Project	IEEE 802.16 Broadband Wireless Access Working Group < http://ieee802.org/16 >	
Title	Improved CTC Performance	
Date Submitted	2005-03-15	
Source(s)	T. Keith Blankenship Yufei Blankenship Brian Classon Motorola	keith.blankenship@motorola.com yufei.blankenship@motorola.com brian.classon@motorola.com
	Alek Purkovic Nortel Networks	apurkovi@nortelnetworks.com
	John Benko Marie-Helene Hamon France Telecom Research & Development	John.Benko@francetelecom.com mhelene.hamon@francetelecom.com
	John Humbert Sprint	john.j.humbert@mail.sprint.com
	Masoud Olfat Nextel Communications, Inc.	masound.olfat@nextel.com
Re:	IEEE P802.16-2004/Cor1-D1 (2005-02-11)	
Abstract	This contribution demonstrates that the convolutional turbo code (CTC) interleavers for block sizes 120 bytes and above were selected incorrectly. By selecting different interleaver parameters for these block sizes, the errors can be corrected without implementation impact. The difference between the proposed parameters and the existing parameters is at least 0.5 dB and in some cases up to 1.3 dB in AWGN at 10^{-4} FER.

Purpose	To correct CTC channel coding interleaver parameters when supporting H-ARQ.	
Notice	This document h

Figure 1+. FER performance for currently specified CTC interleavers.

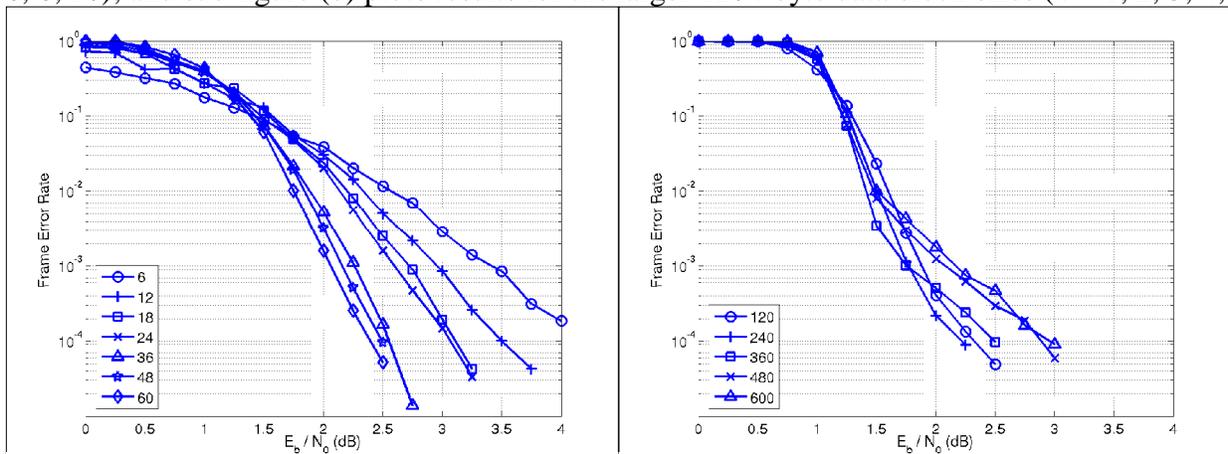
The performance of the 6*n*-byte block sizes displays the expected turbo code behavior of improving performance with increasing block size. Furthermore, no error floor is discernable down to a FER of 10⁻⁴. However, the performance of the 120*n*-byte block sizes displays the opposite. Here, the performance degrades with increasing block size (above 240-byte) and a distinct error floor is present.

Figure 232. Performance with new CTC interleaver parameters.

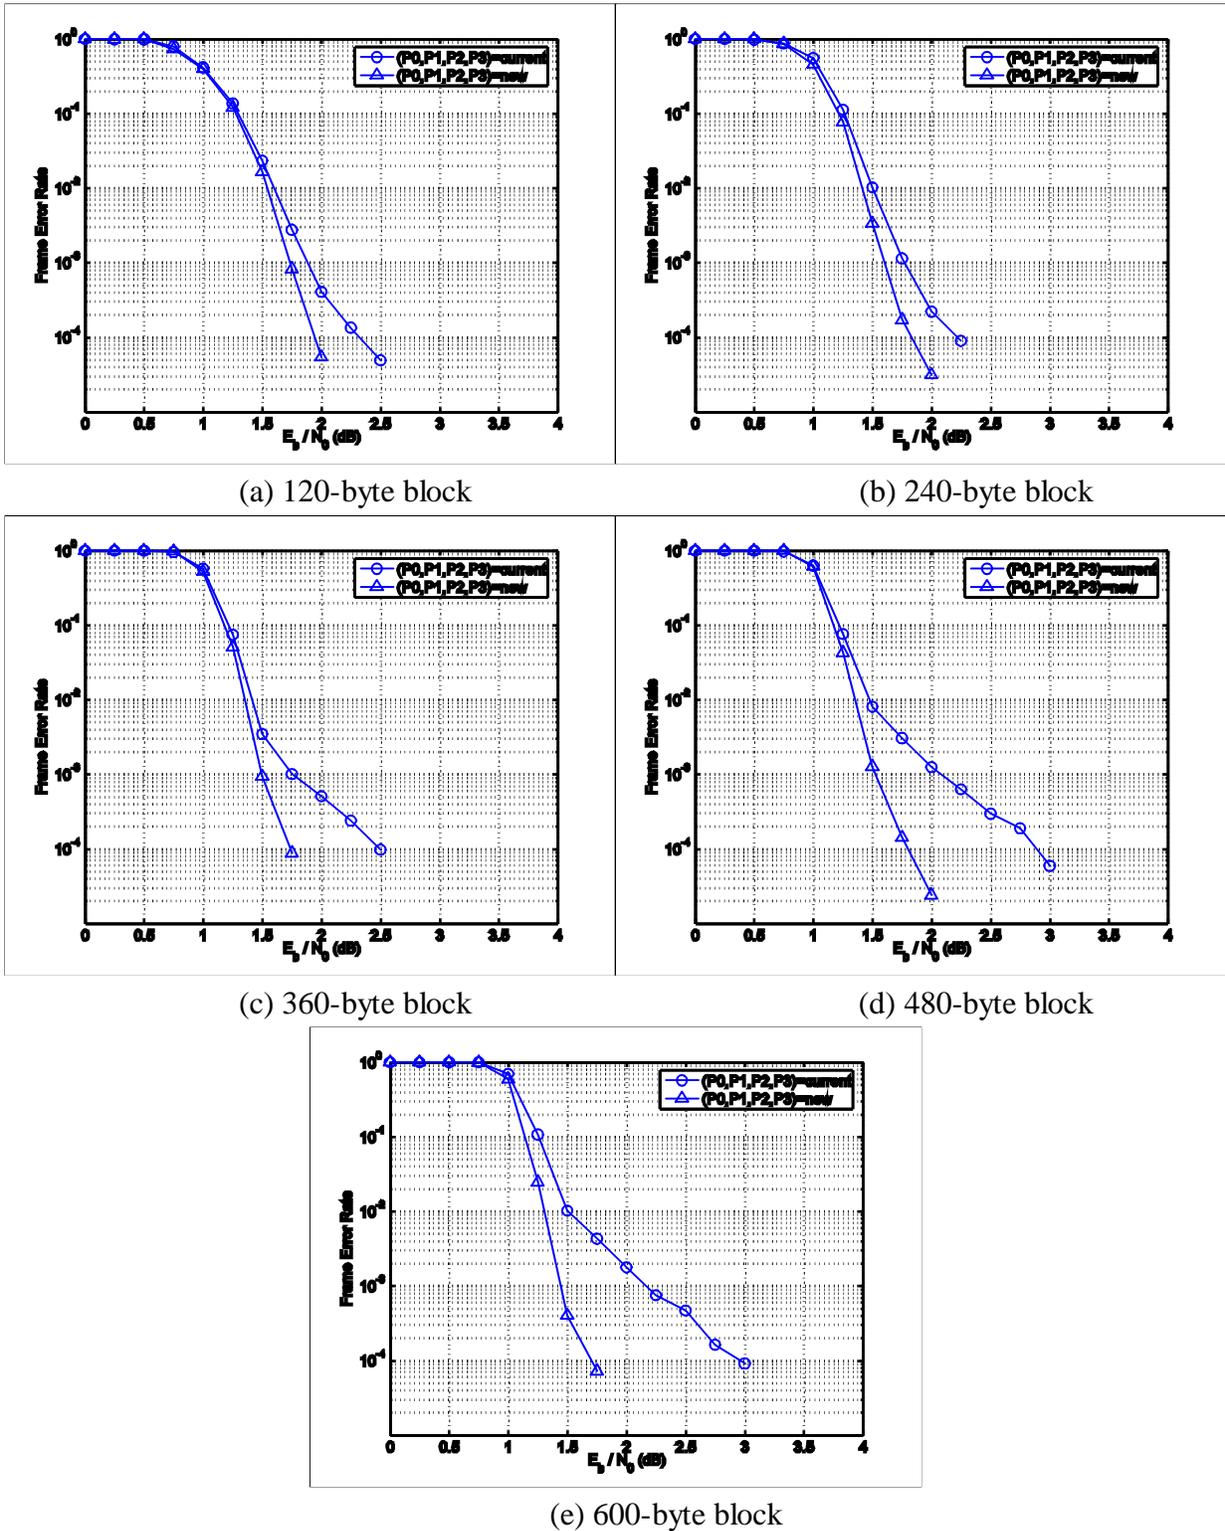
A new set of CTC interleaver parameters was designed to correct the performance deficiencies of the $120n$ -byte block sizes. The new parameters were selected according to guidelines prescribed in [1]. The FER performance (rate-1/2, binary modulation, static AWGN channel, 7.5 decoding iterations, and “genie” circulation state knowledge) with the new parameters is plotted in [Figure 2](#)~~Figure 3~~~~Figure 2~~. The figure shows that the new parameters correct the performance deficiencies of the current parameters. At $\text{FER} = 10^{-4}$ the performance with the new parameters is at least 0.5 dB and in some cases up to 1.3 dB better than with the current parameters.

Figure 353. Cross simulation provided by Nortel on the existing and new CTC interleaver parameters.

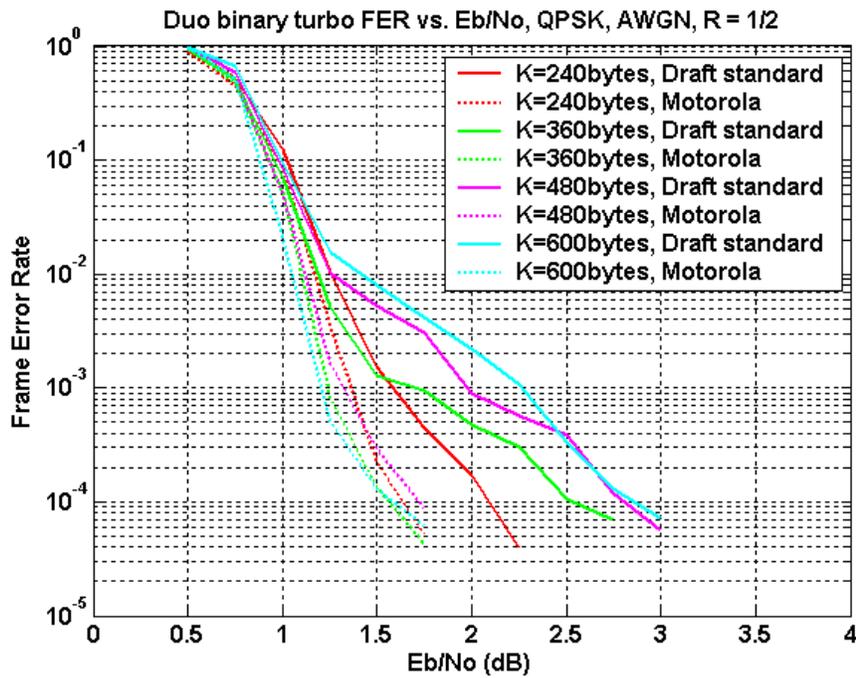
The proposed interleaver parameters have been independently tested by Nortel in comparison to the existing parameters. Their results in [Figure 3](#)~~Figure 5~~~~Figure 3~~ further support the significant improvement achieved by the proposed parameters.
